From: noreply@epropertyportal.com,
To: wsgc96@aol.com,
Cc: mmonxhwedey@nygisgroup.com,
Subject: Submission Review comments requested.
Date: Wed, Apr 14, 2021 3:52 pm

Reference number: 377

Job location : 7 STRAWBERRY LN [SBL:2.50-19-20]

Type of work : ARB Approval

2 TEE CABLE RAILING SYSTEM
TE-01

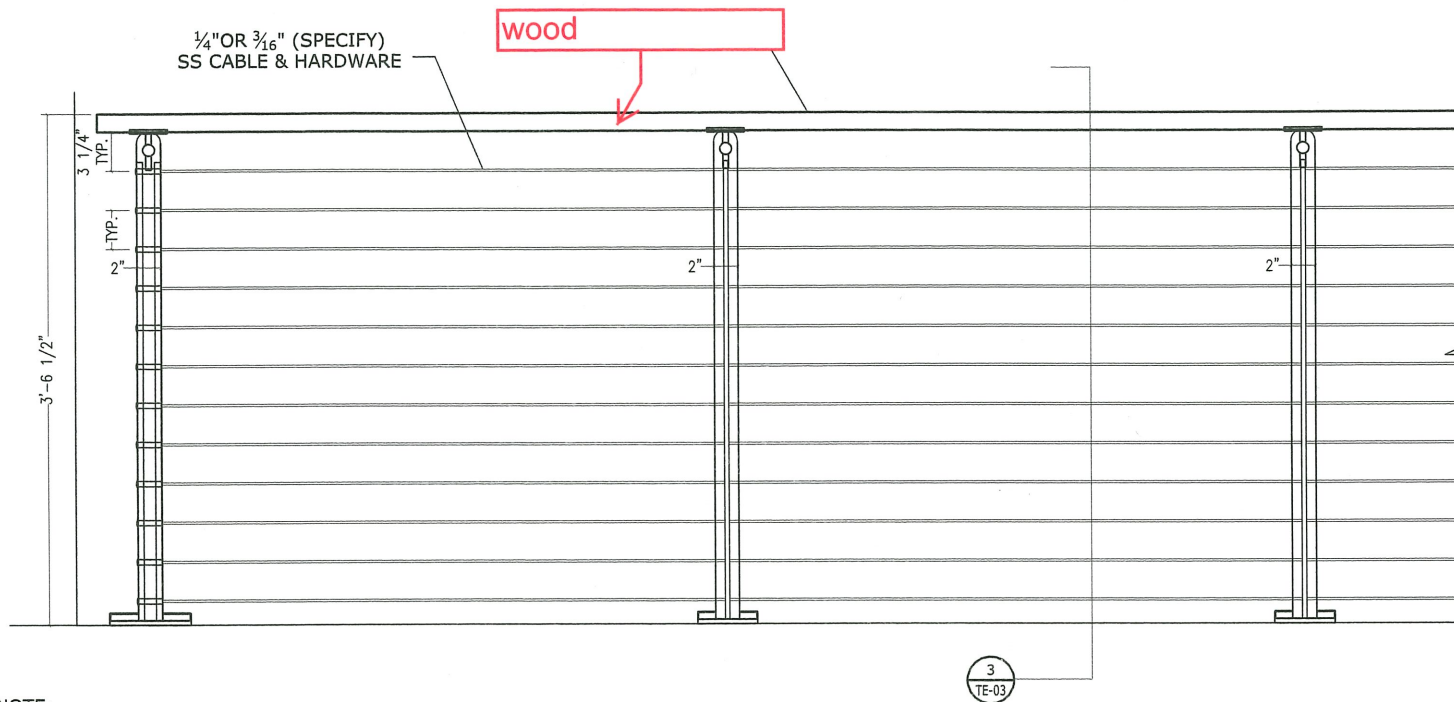
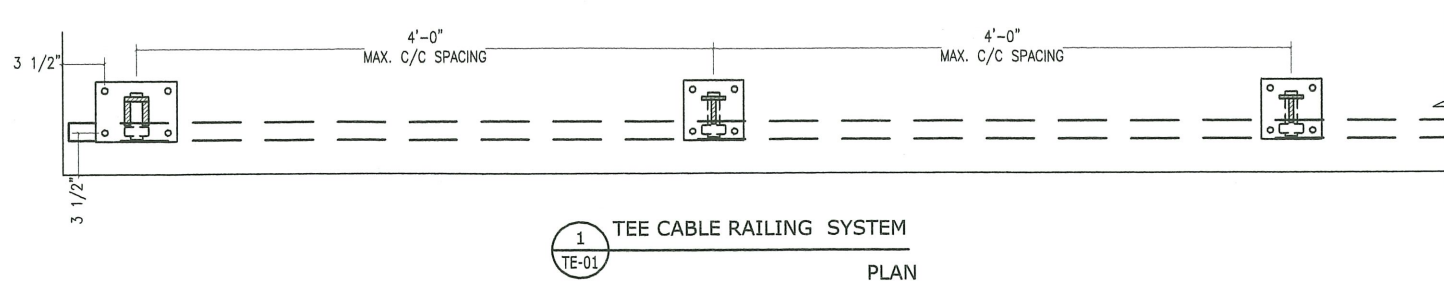
Comments : Hello, I received the following comments from the ARB in regards to your application for 7 Strawberry Lane: Door #1 on Proposed elev. shows immediate drop off as you walk out the door. Stairs and railings at same location not shown in elevation. (Short stair). Show sample of lattice in cut sheet or photo. Proposed Railings not shown on drawings. (Shows existing.) If you would like to make a submission based on these comments, please drop off three sets and everything on an unlocked flash drive before 4:00pm on 4/19/2021.
